**Re: EB-2019-0049 – Kitchener-Wilmot Hydro Inc. 2020 Cost of Service Rates
Interrogatories of the Vulnerable Energy Consumers Coalition (VECC)**

REQUESTOR NAME	VECC
TO:	Kitchener Wilmot Hydro Inc. (KWHI)
DATE:	July 10, 2019
CASE NO:	EB-2019-0049
APPLICATION NAME	2020 COS Rate Application

Reference: Exhibit 2, PDF pg. 358

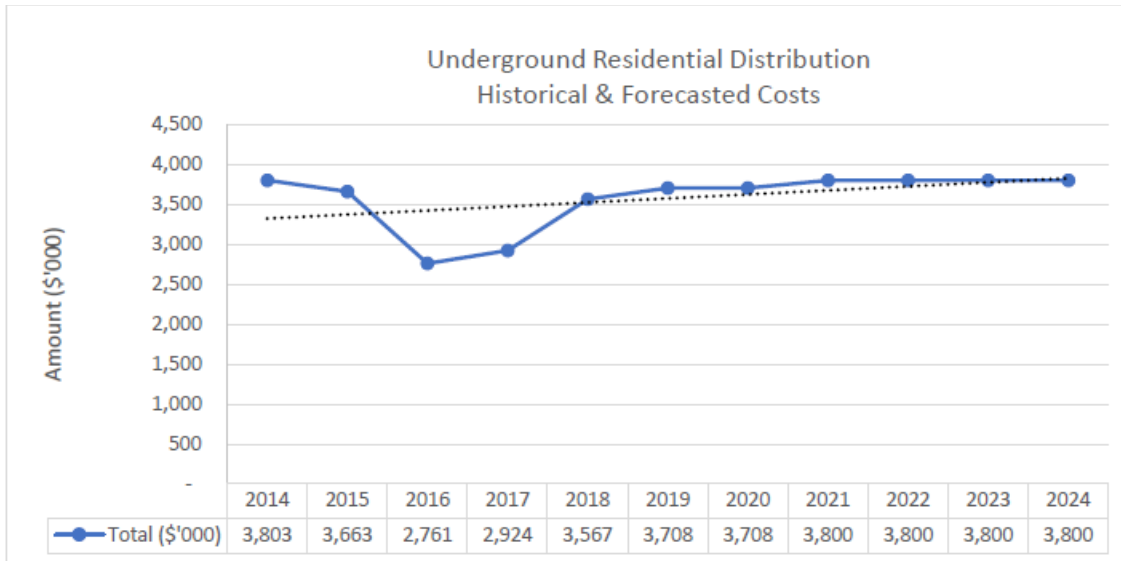
- a) Please comment on the reason(s) for the decline in underground distribution capital expenditures in 2016 and 2017 (as shown on graph below).
